Midway City Council  
17 September 2019  
Regular Meeting

Watts Remund Farms PUD /  
Master Plan Amendment

## CITY COUNCIL MEETING STAFF REPORT

**AGENDA ITEM:** Master Plan Amendment

WATTS ENTERPRISES  
 REMUND FARMS  
 SITE MASTER PLAN

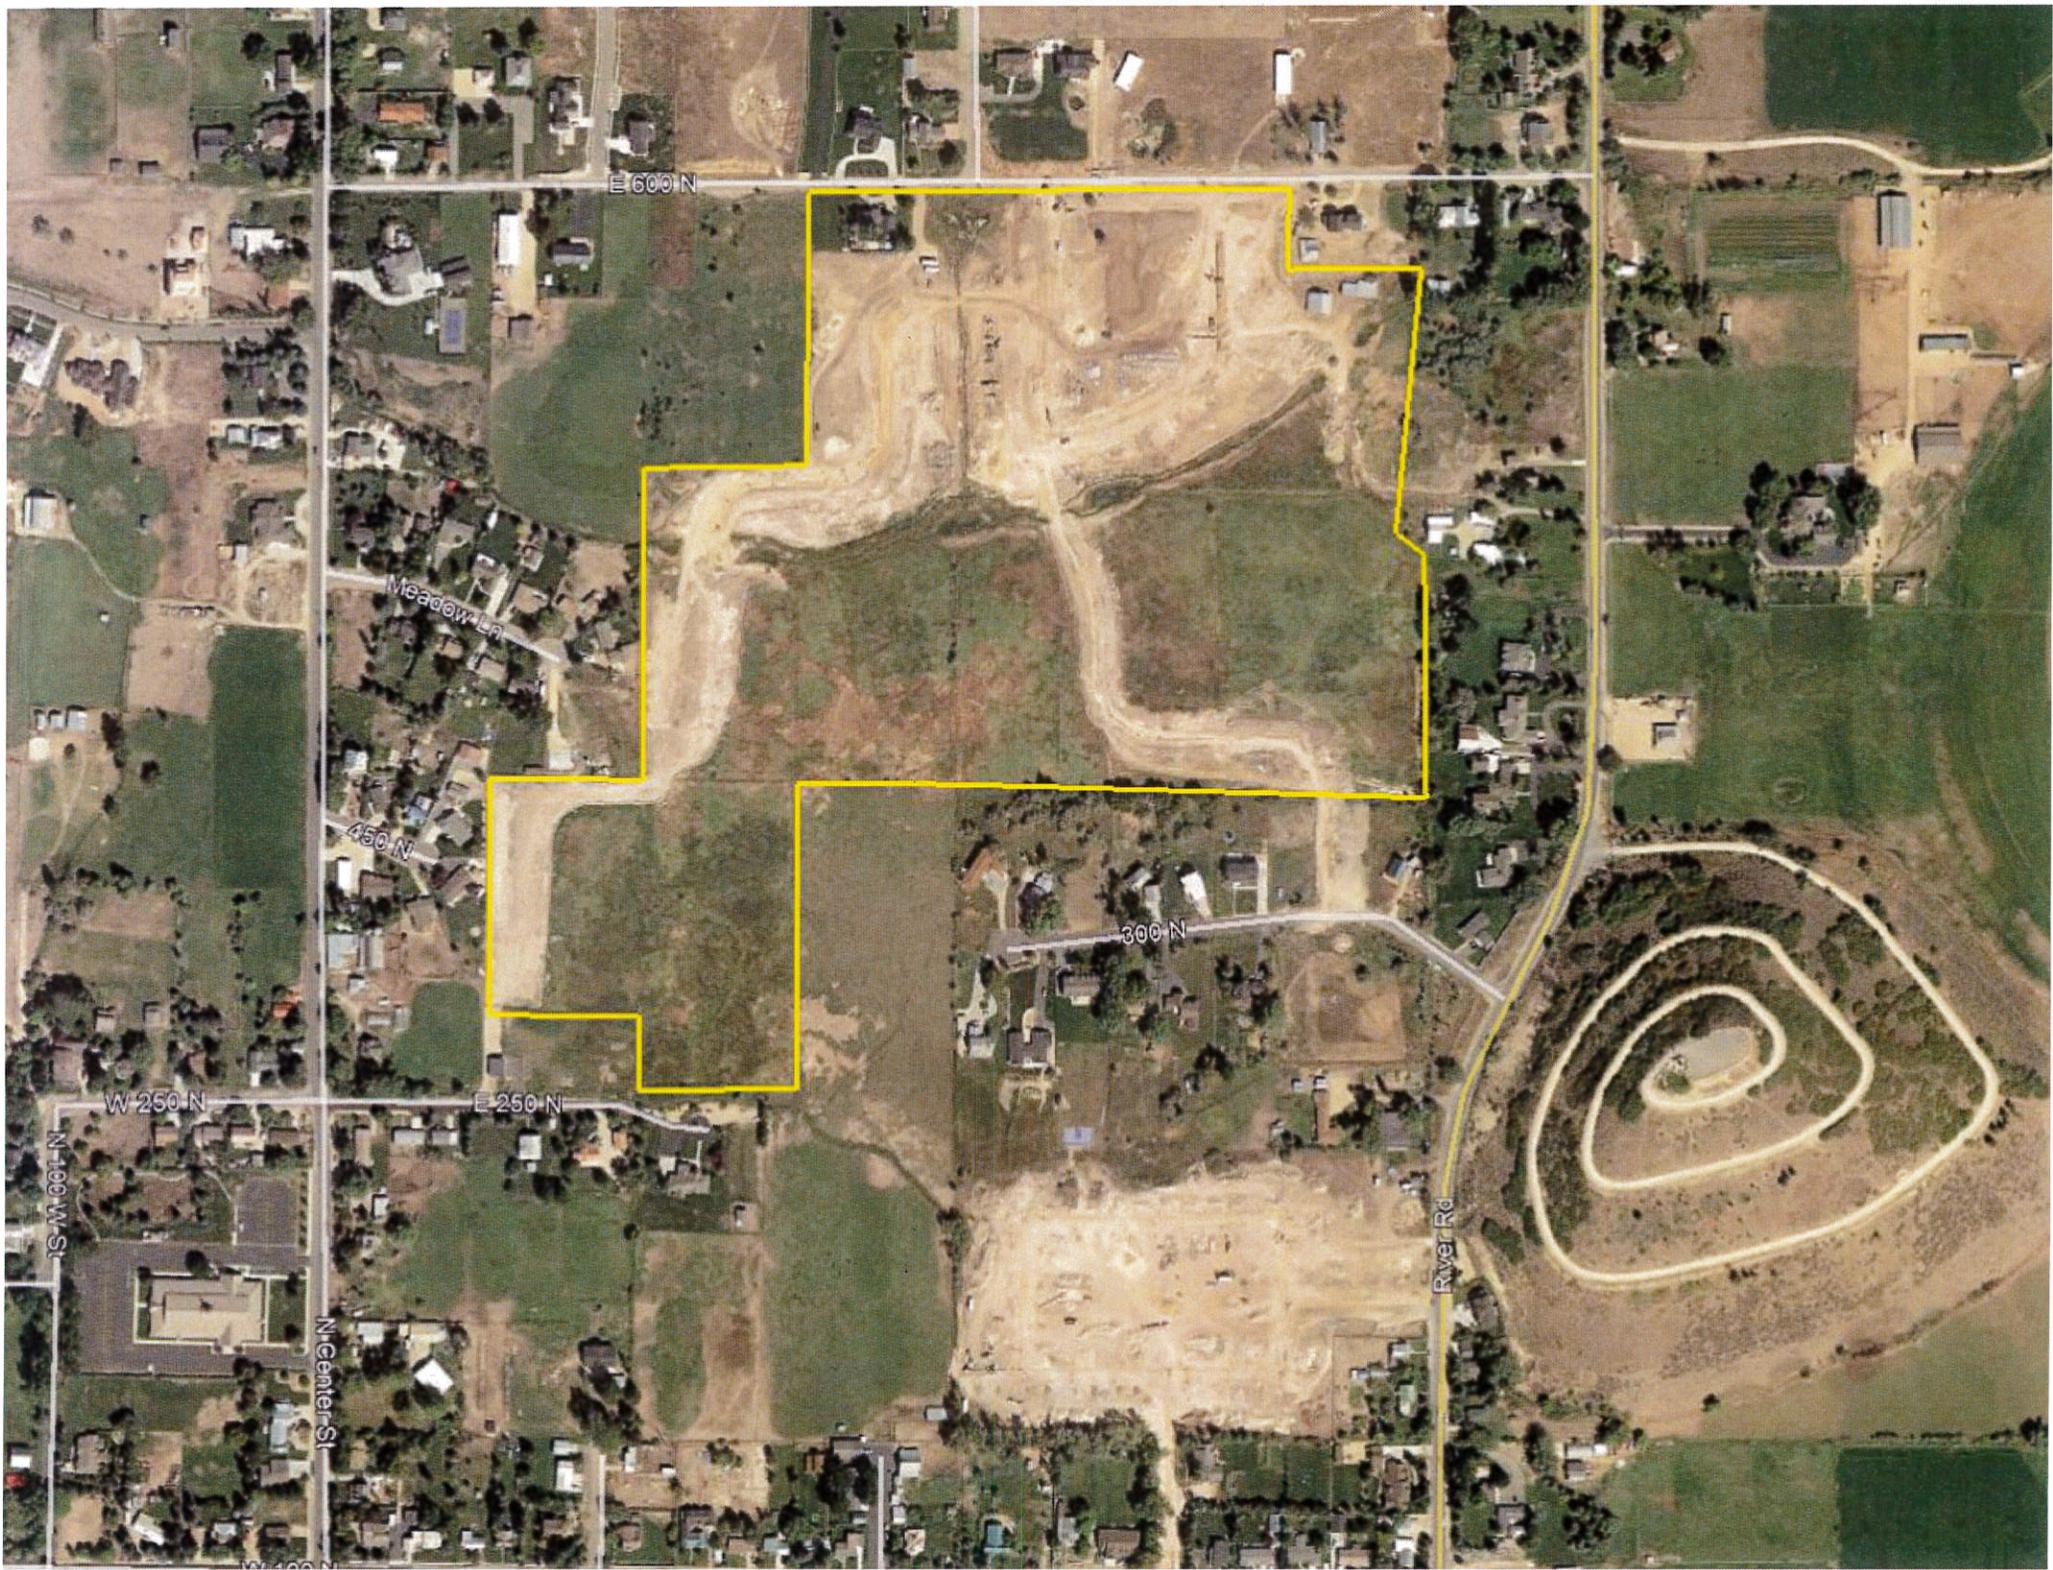
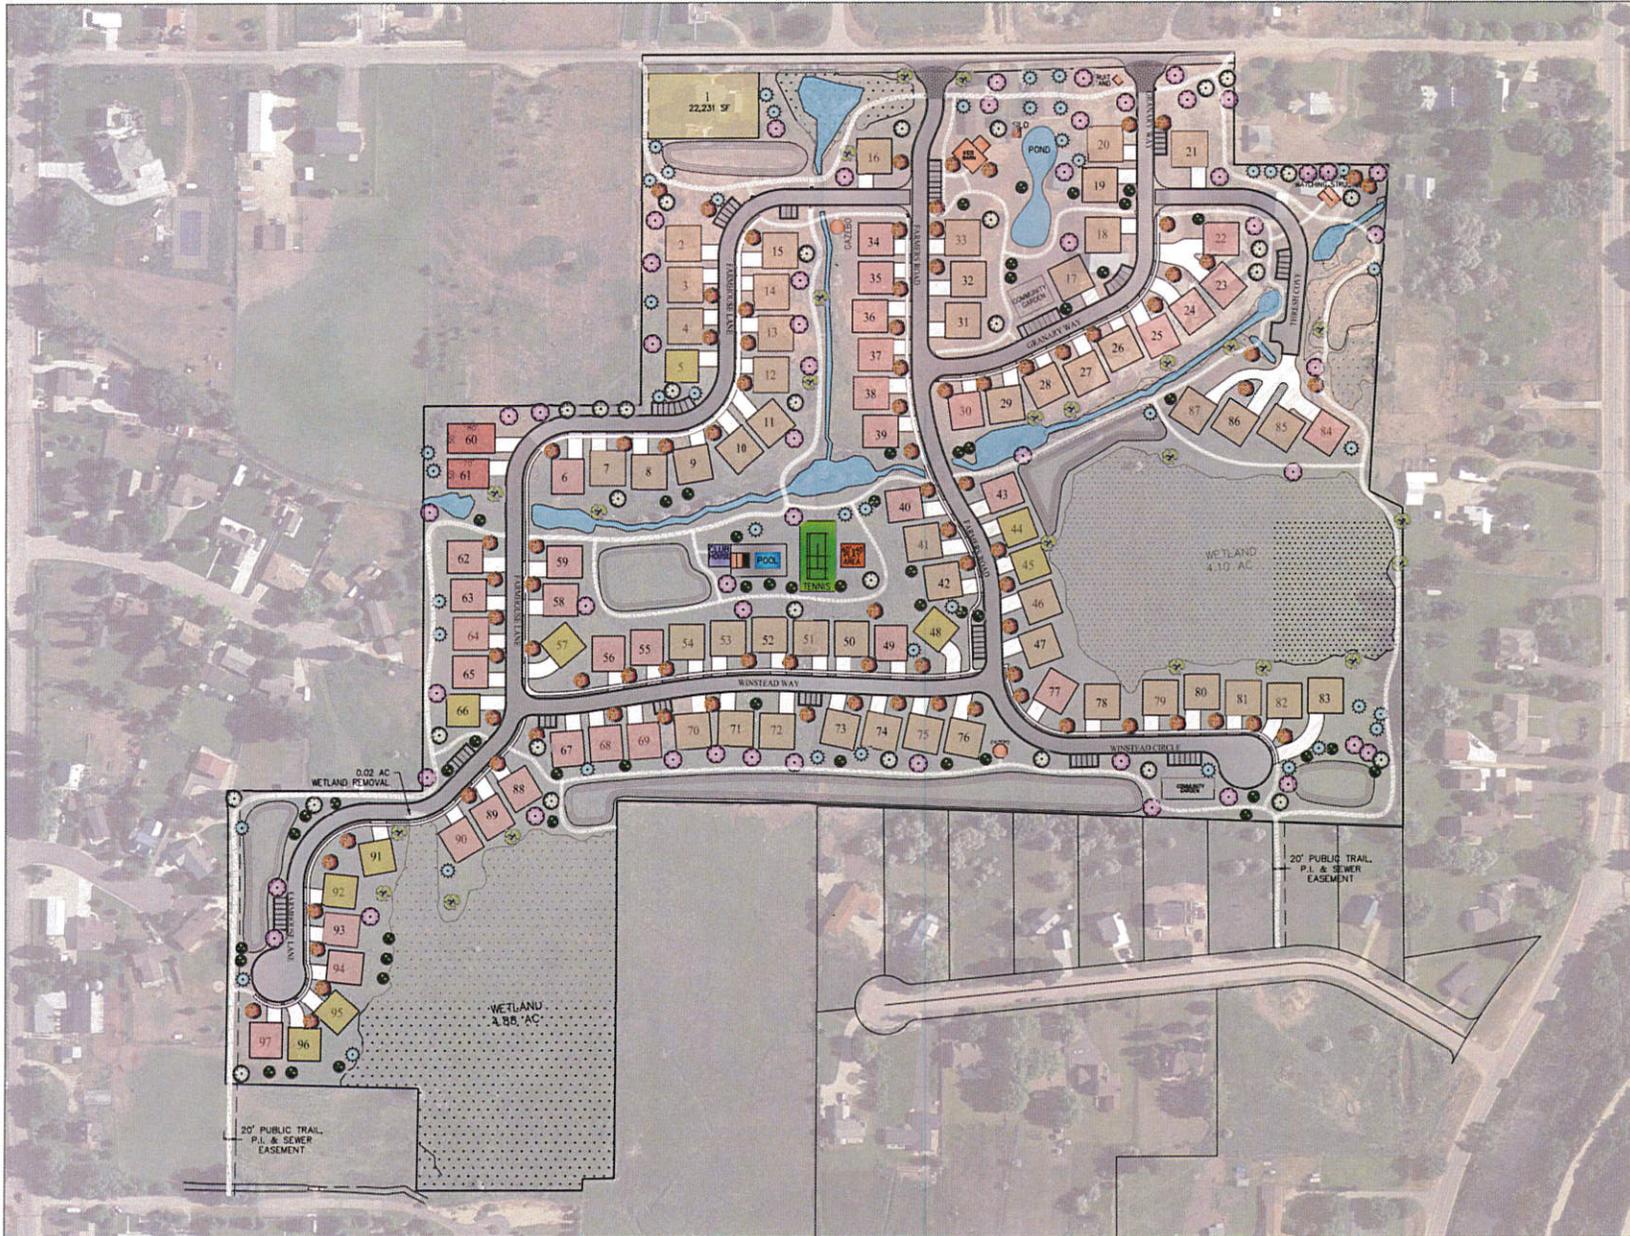
*Pad 84 amendments* – The applicant is proposing to amend the dimension of pad 84 and the driveway access to the unit. The current dimensions of the pad are 55' x 60' and the proposed dimensions are 70' x 55'. The overall area of the pad will increase by 550 sq. ft. The driveway modification would change the driveway from accessing the west side of the pad to the north side of the pad.

**Motion:** Commissioner Streeter: I make a motion that we approve the proposed Master Plan amendment 1 and 2 of Remund Farms, to add limited common areas behind 37 units and that each limited common area is 12' deep, and that we adjust the pad dimensions and driveway of unit 84 to 55x70 feet from the current of 55x60 feet. Also, to remove the private trail that runs south from lot 84 to 87.

1. Only private areas that do not extend into the 25' buffer area around wetlands are allowed.

AMENDED PHASING PLAN  
 REMUND FARMS  
 WATTS ENTERPRISES

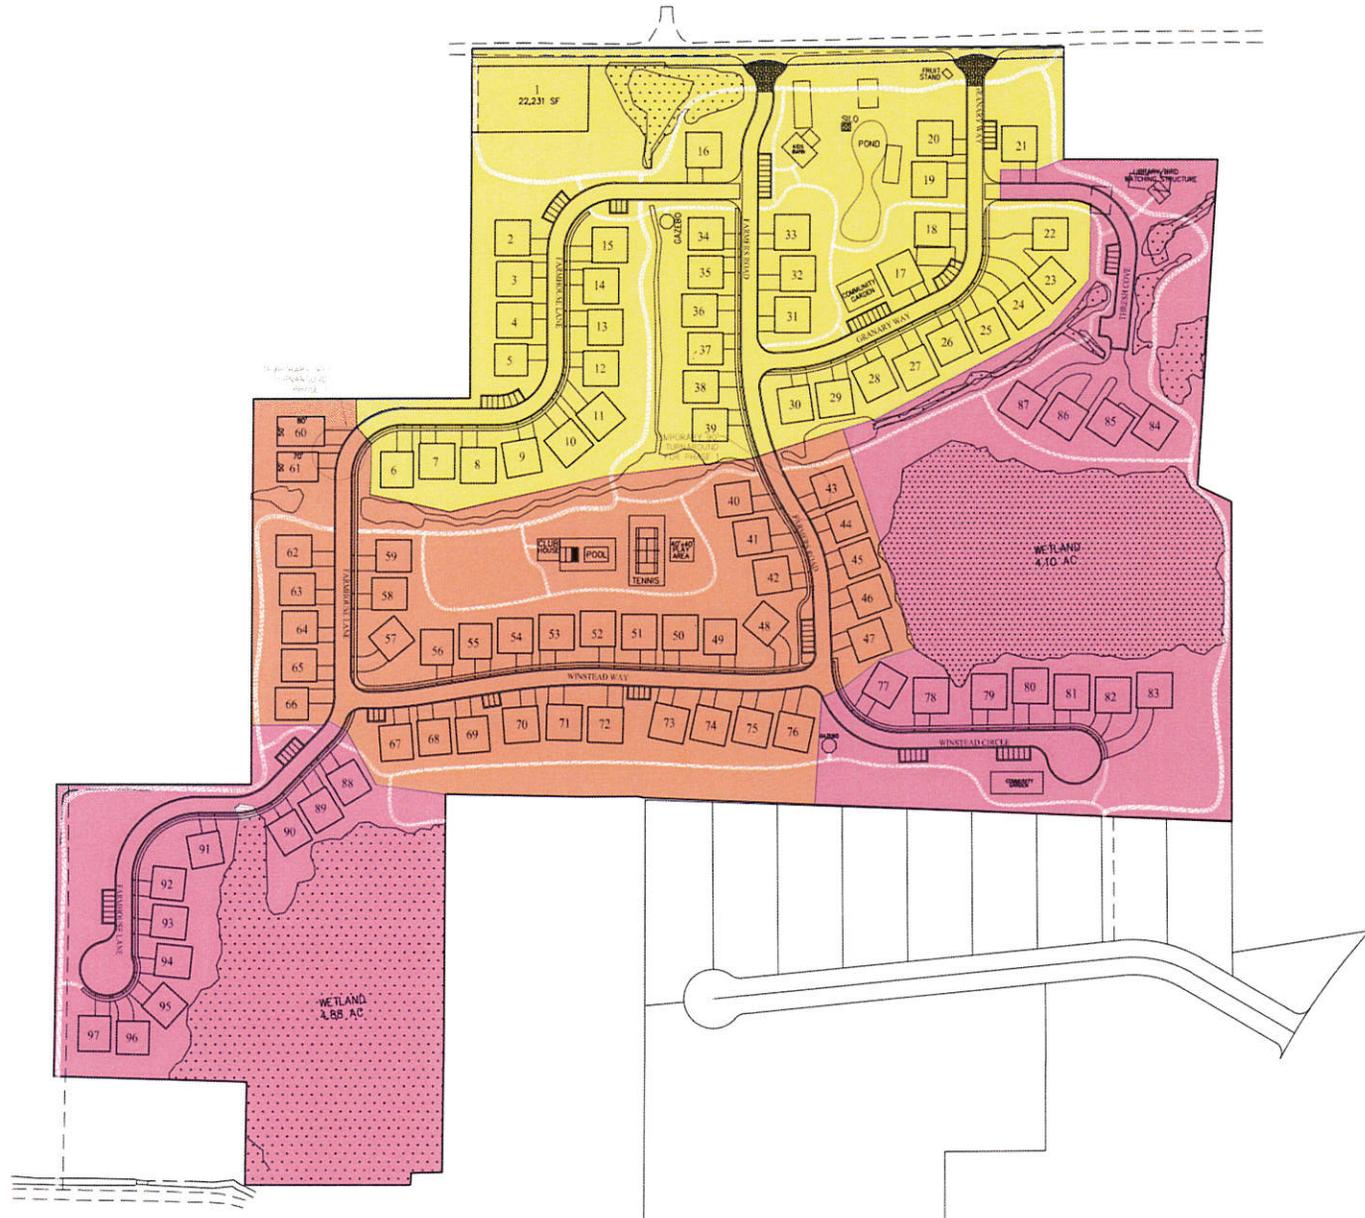
REMOVE SHEET 2-16, COUNCIL ACTING  
 FOR UNITS 79-83, 84 & 88.  
 PRIVATE AREA-TYPE 2 HAS BEEN REMOVED  
 FOR UNITS 88 AND 84. NO TYPE 2 AREAS  
 ARE WITHIN 20' OF THE WETLANDS.  
 UNIT 84 IS 70' X 80'.  
 UNITS 86-72 HAVE BEEN ROTATED FOR  
 BACK OF UNIT WINGS TO THE TRIPPOCKS.

- PHASING AREA UNITS
- PHASE 1 15.88 ACRES 1-30
- PHASE 2 18.08 ACRES 40-52
- PHASE 3 2.30 ACRES 63-69
- PHASE 4 4.13 ACRES 60-67
- PHASE 5 0.24 ACRES 77-83
- WETLANDS
- LOCUS
